**ZONING AMENDMENT**

& SUBDIVISION STAFF REPORT Date: August 7, 2008

**SUBDIVISION NAME** JGL Square Subdivision

**LOCATION** Northwest corner of Zimlich Avenue and West I-65 Service

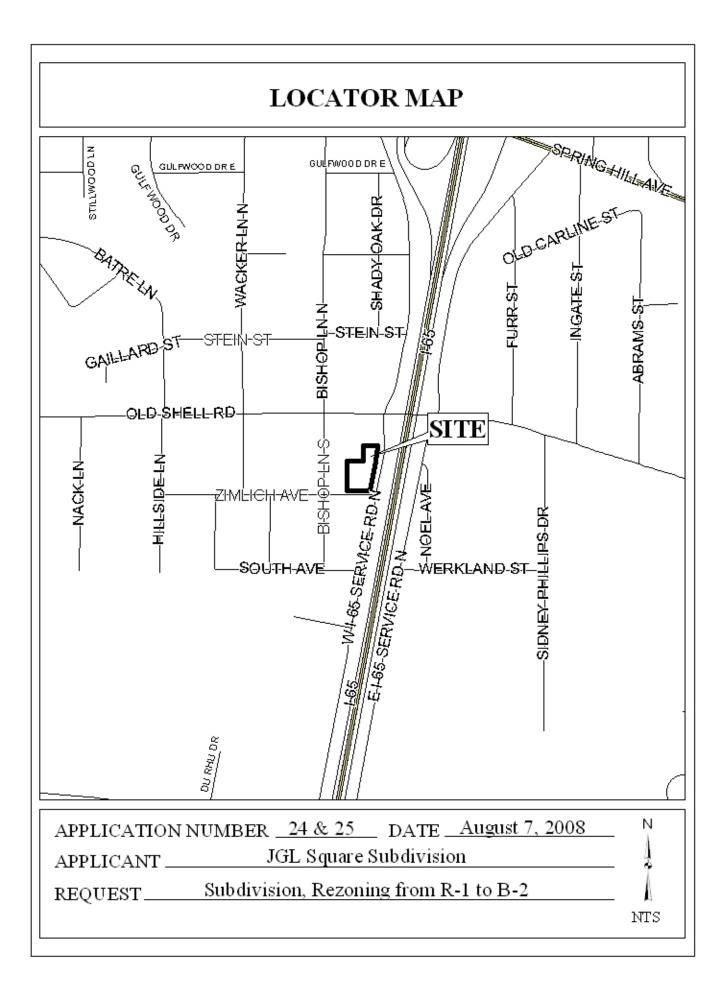
The site fronts onto Zimlich Avenue, a minor street which will require an additional 5' dedication at this location. As shown on the proposed plat, if approved, dedication sufficient to equal 50' of right-of-way should be shown on the final plat.

Proposed Lot A will have approximately 150' of frontage onto Zimlich Avenue and 265' onto the I-65 Service Road therefore access management is a concern. The applicant is proposing two curb-cuts onto the I-65 Service Road and one curb cut onto Zimlich Avenue. A note should be placed on the final plat that states Lot A is limited to two curb cuts onto the I-65 Service Road with the size, design and exact location to be approved by Traffic Engineering and conform to AASHTO standards. Due to the residential nature of Zimlich Avenue, access should be denied.

The 25-foot minimum building setback is depicted for proposed Lot A along the service road, but is shown as 20' along Zimlich Avenue. The plat should be revised to be 25' along both street frontages. This would also be required on the final plat, if approved.

The dumpster depicted does not meet setback requirements. The dumpster must be at least 10' from adjacent residential uses. In addition, the HVAC unit must also meet all required setbacks.

Aerial photographs show what appears to be a residence on proposed Lot A. According to the proposed site plan, the residence it to be demolished. A demolition permit should be obtained prior to the signing of the final plat.

- 1) The site is limited to two curb cuts onto the I-65 Service Road with access denied to Zimlich Avenue The size, design, and exact location of all curb cuts are to be approved by Traffic Engineering and conform to AASHTO standards;

- 2) Depiction of a 25' minimum building setback line on all street frontages;
- 3) Dedication of adequate right-of-way to equal 50' on Zimlich Avenue;
- 4) Obtainment of a demolition permit for the residence located on Lot A prior to the signing of the final plat;
